SERVICE BULLETIN 00134 REV 1

Subject: Horizontal Stabilizer Forward Attach Bolt Position

Affected Models: RV-4, RV-6/6A, RV-7/7A, RV-8/8A

FIGURE 1: LONGERON REDUCED EDGE DISTANCE
(HORIZONTAL AND TOP DECK REMOVED)

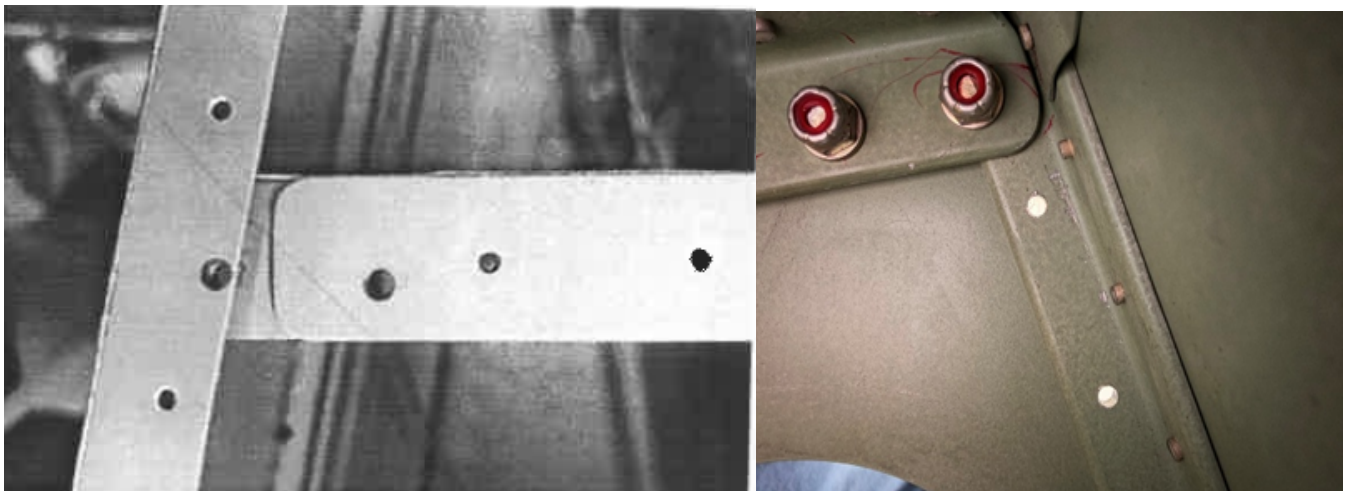
The strength of this joint and the airframe structure as a whole is relatively tolerant of variations in the outermost bolt hole position in the fuselage longerons, even where this involves less than what are normally considered minimum edge distances, zero edge distance and even bolt holes cutting through the inner edge of the longeron flange.

In the fuselage longeron, spanwise locations of the outermost bolt positions that result in the hole for the outboard bolt having a reduced edge margin in the longeron, cutting through the inboard edge of the longeron or missing the longeron altogether is acceptable. See Figure 1.

FIGURE 2: RV-7 DEG 27A TYPICAL HORIZONTAL STABILIZER ATTACH FRONT VIEW

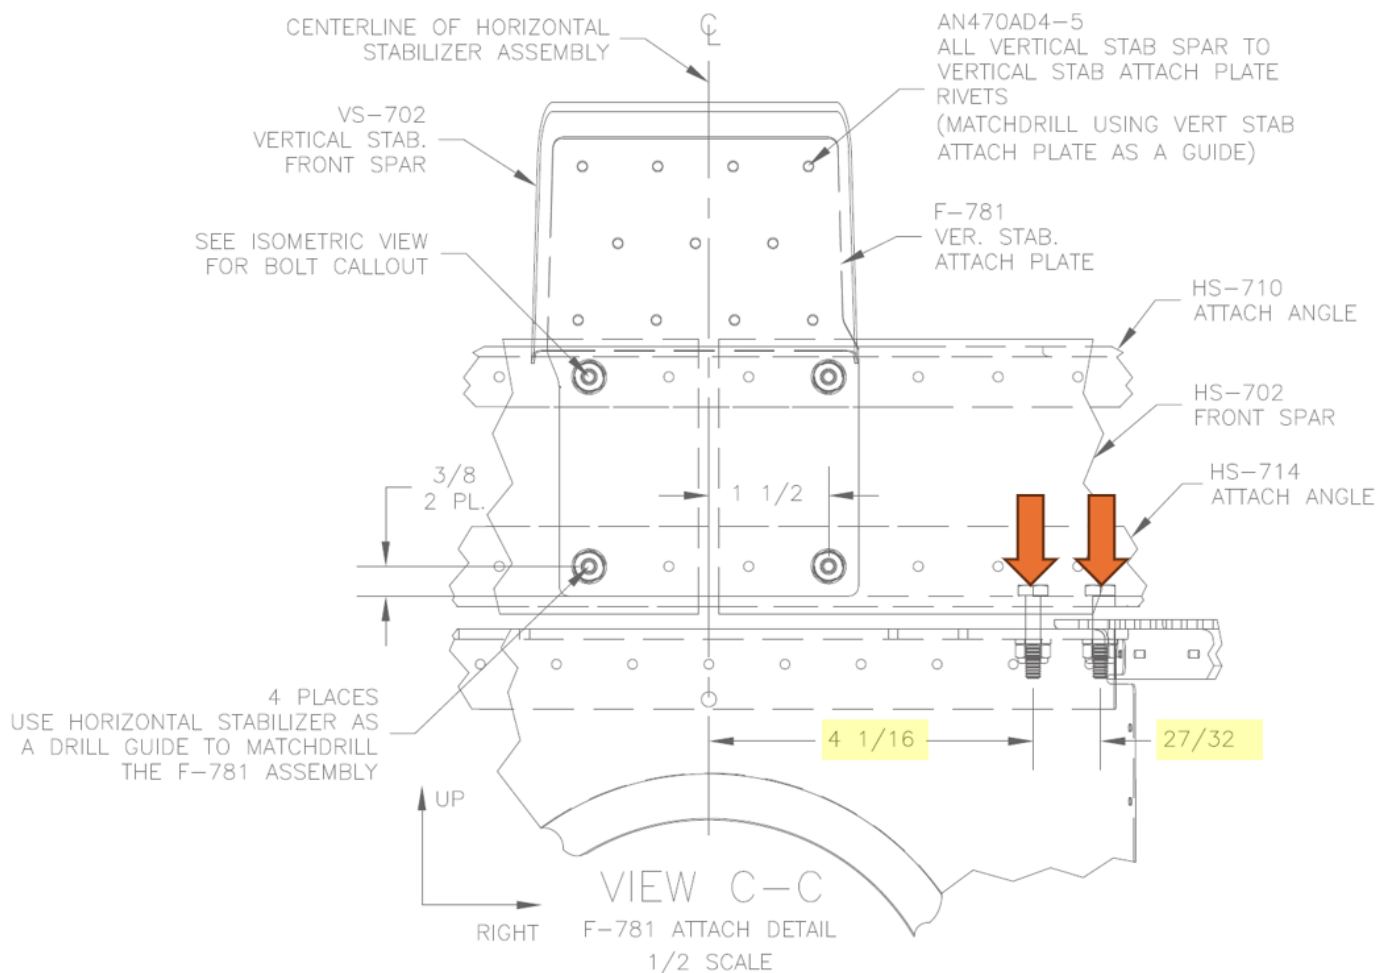
Step 2: Measure the distance between the attach bolts on one side of the aircraft (see the set of bolts marked with arrows in Figure 2 with a distance of 27/32 inches between them). At minimum the distance between the bolts should be 25/32 inches. If the distance is less than 25/32 inches contact Van's Aircraft for further assistance.

Step 3: Measure the edge distance between the center of each bolt hole and the forward edge of the HS-714 Attach Angle. Repeat the measurement for the forward edge of the F-710B Angle. See Figure 2 and Figure 3. In no case may the edge distance be less than $e/D = 1.5$ (e/D the distance from the center of a hole to the edge of the part divided by the diameter of the hole $.1875 \times 1.5 = .281$). If the e/D is less than 1.5 contact Van's Aircraft for further assistance.

For example, Figure 2 the center of the bolt pattern would be 4 1/16 inches plus half the distance between the bolts or half of 27/32 inches which results in a bolt pattern center distance to the centerline of 4.484 inches.

FIGURE 4: ACCEPTABLE BOLT POSITION CHART

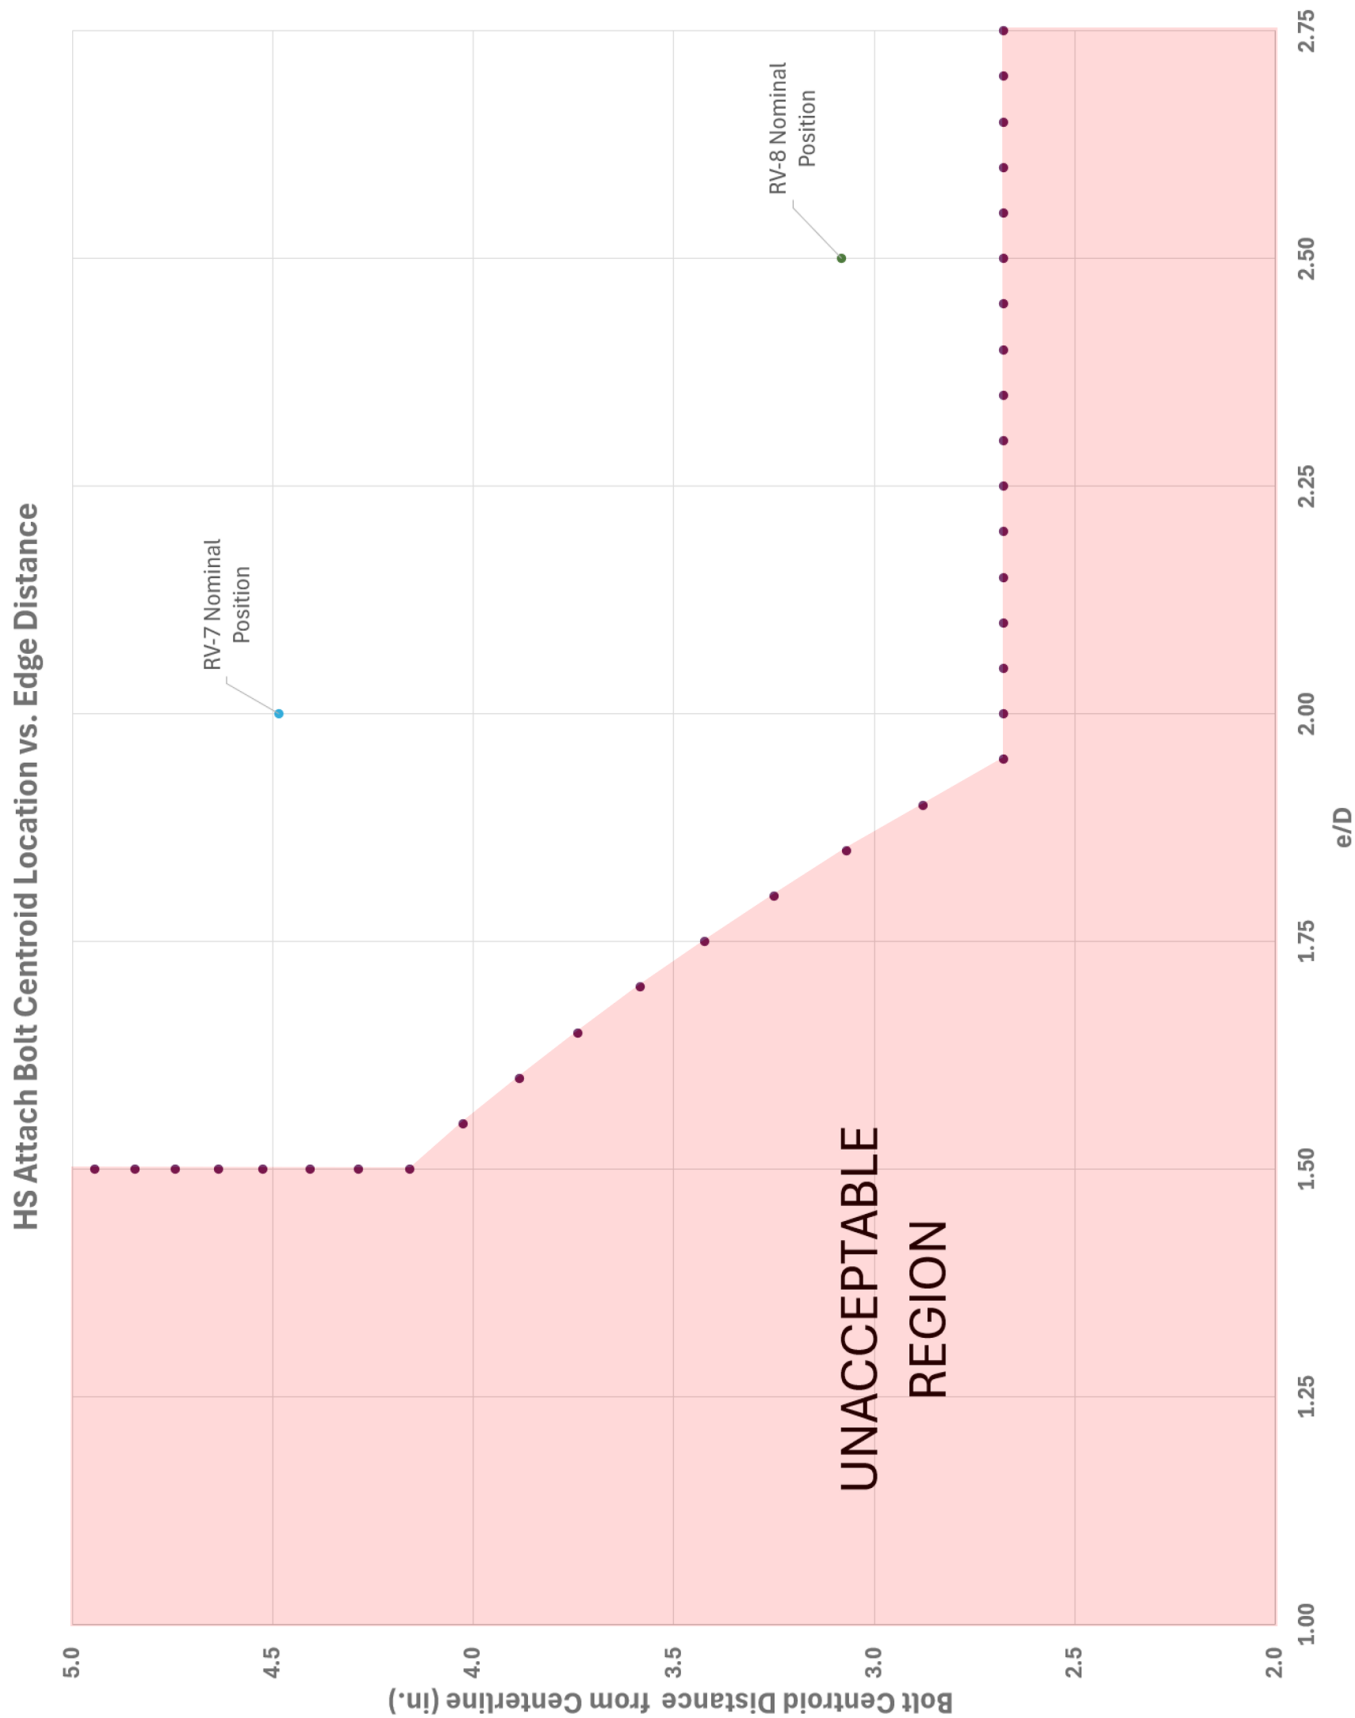
For the edge distance between the center of the bolt position and the forward edge of the F-710B Angle and HS-714 Attach Angle, the minimum acceptable e/D may be more than 1.5 depending on the results obtained in Step 5 and the values in the chart in Figure 4.

Step 5: Plot the e/D value between the hole center and the forward edge of the attach angles from Step 3 and the bolt pattern center distance to the centerline measured in Step 4. The plotted point must be outside the unacceptable region noted in Figure 4.

For example, the bolt pattern distance from Step 4 was 4.484 inches. Assume the nominal e/D of 2. This example corresponds to the RV-7 nominal point given on the chart in Figure 4. If the point on the chart is within the unacceptable area on the chart contact Van's Aircraft for further assistance.

FIGURE 5: OUTBOARD BOLT POSITION & e/D

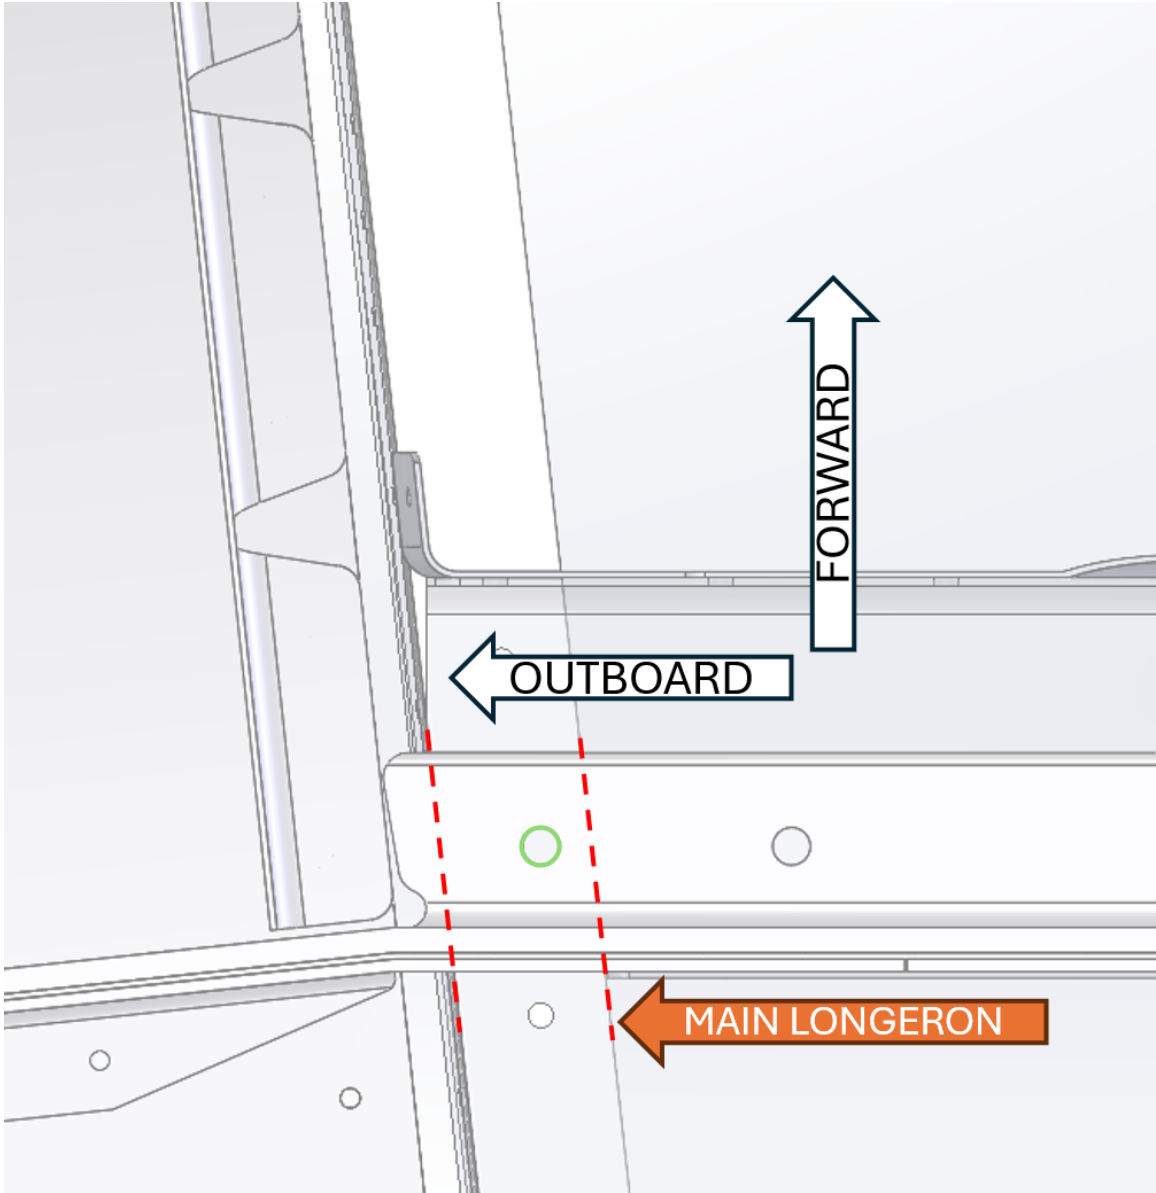
Measure the edge distance between the center of the outboard most bolt holes and the outboard edge of the HS-714 Attach Angle. In no case may the edge distance be less than $e/D = 1.5$. If the e/D is less than 1.5 contact Van's Aircraft for further assistance.

Check to ensure that the outboard end of F-710B is resting on the F-718 Longerons. Measure the edge distance between the center of the outboard most bolt holes and the outboard edge of the F-710B Angle. In no case may the edge distance be less than $e/D = 1.33$ ($.1875 \times 1.33 = .249$) unless the entire diameter of the outboard most bolt hole is within boundary of the main longeron (see Figure 5) in which case the edge distance of $e/D = 1.00$ ($.1875 \times 1.00 = .188$) is acceptable. If the e/D is less than those specified above contact Van's Aircraft for further assistance.
